**State of California
AIR RESOURCES BOARD**

Executive Order G-70-118-AB

**Modification to the Certification of the
Amoco Oil Company V-1 Bootless Nozzle
Vapor Recovery System**

WHEREAS, Amoco requested certification of a modified V-1 system. The modification consists of the installation of a non-optional Efficiency Compliance Device (ECD) on the nozzle;

Figure 2C-1

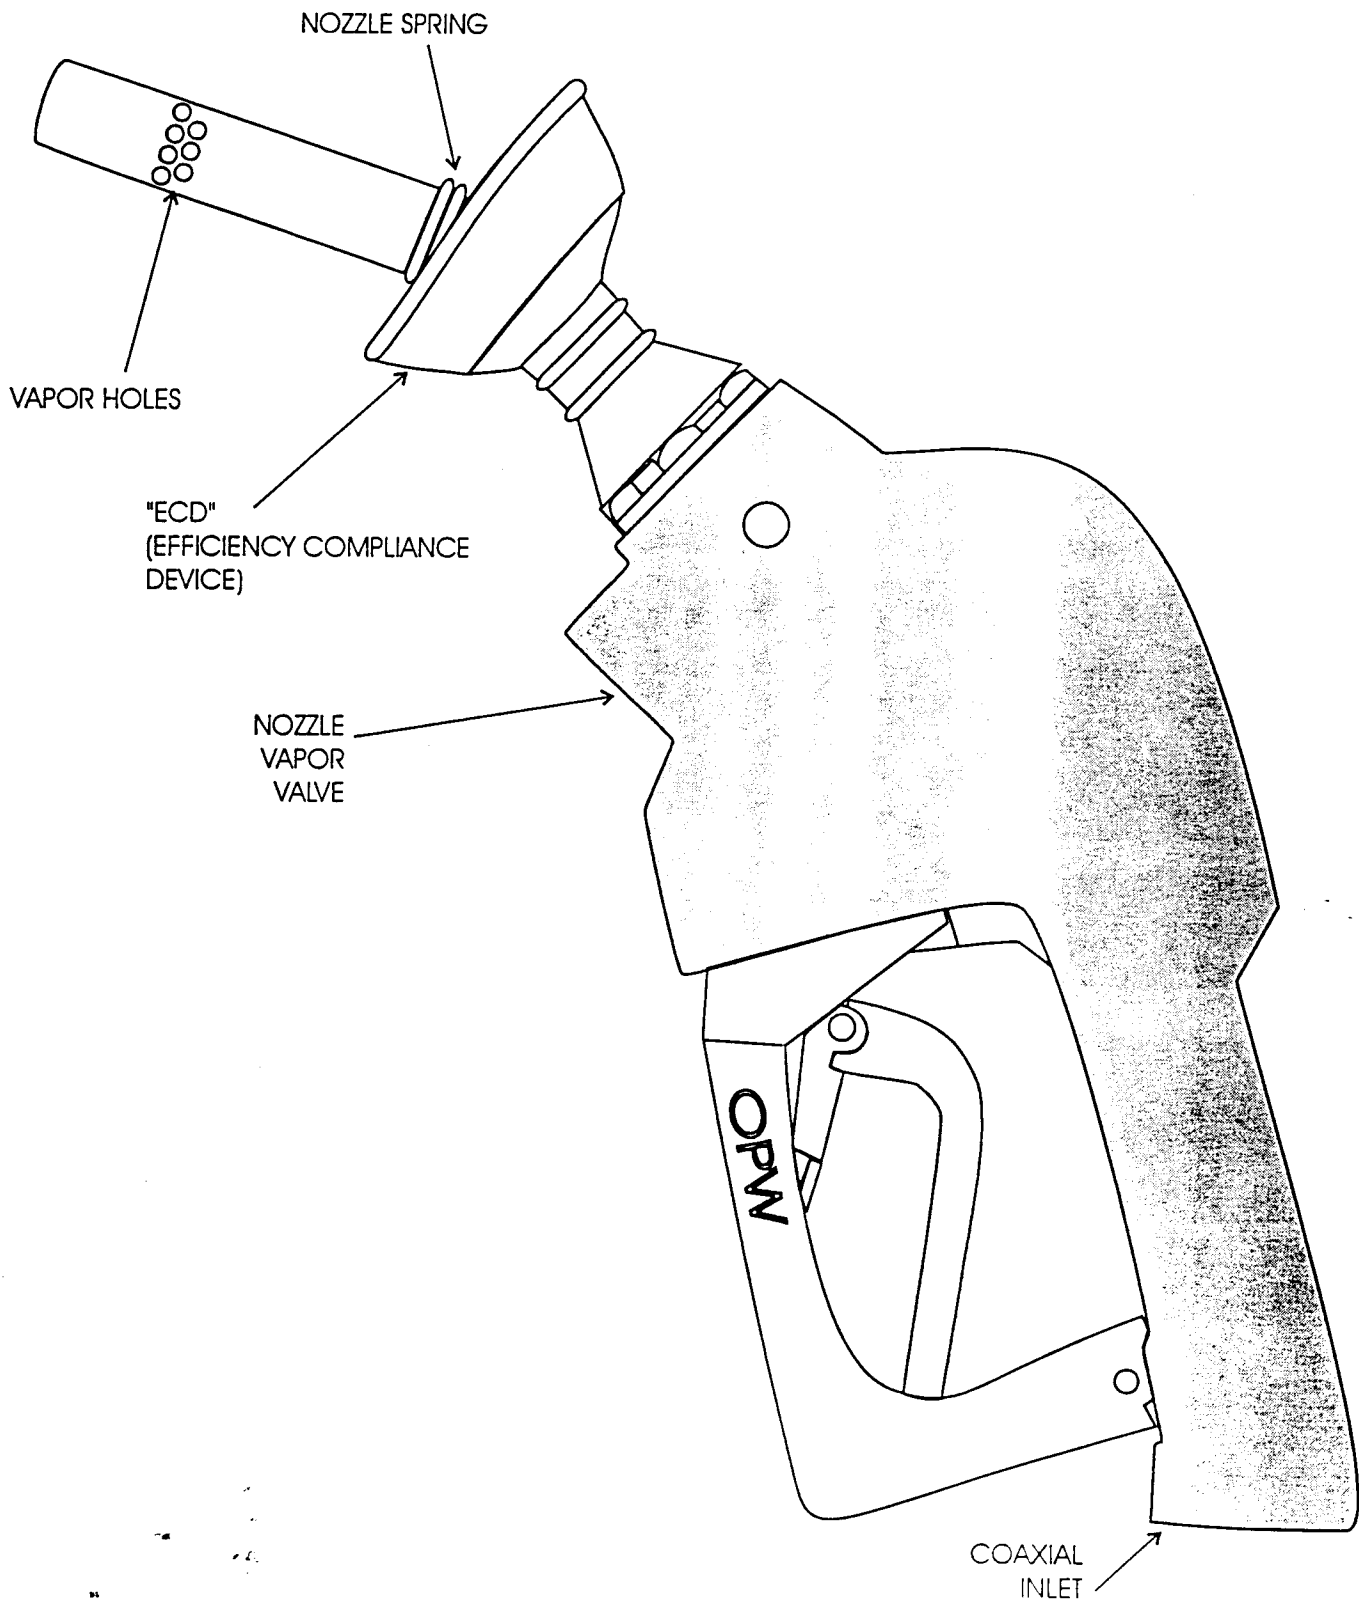
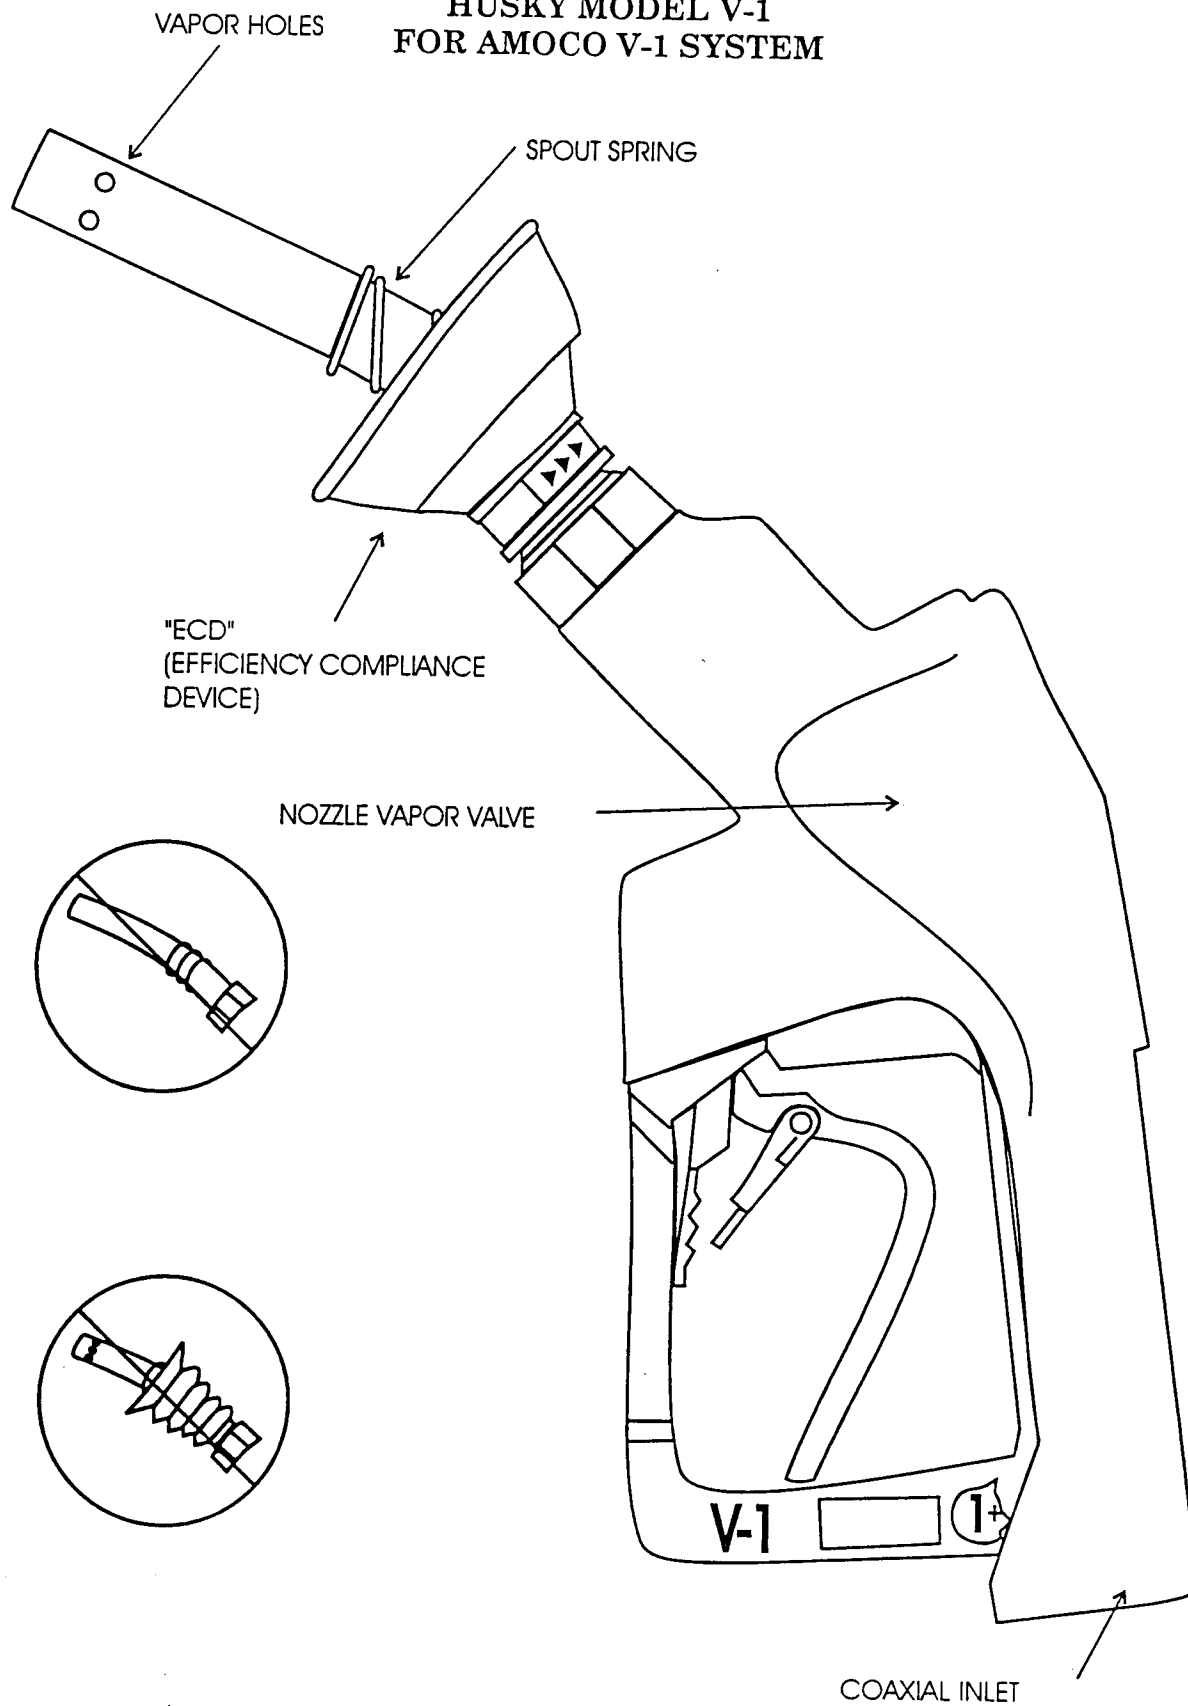
1. An efficiency compliance device (ECD) shall be installed on the Husky V-1 and OPW 11-VAA nozzles at the base of the spout as shown in Figures 2C-1 and 2C-2. Any nozzle with an ECD which is missing is deemed defective and shall be immediately removed from service. For the Husky V-1 nozzle, any ECD which is damaged such that at least one-eighth (1/8) of the diameter is missing, or has cumulative damage equivalent to at least 1/8 of the diameter missing, is defective and shall be immediately removed from service. For the OPW 11-VAA nozzle, any ECD which is damaged such that a slit from the outer to inner edge exists, or has cumulative damage equivalent to this, is defective and shall be immediately removed from service. Any nozzles which was installed without an ECD prior to the issuance of this Order shall be equipped with an ECD within 60 days of the effective date of this Order, or shall then be considered defective.
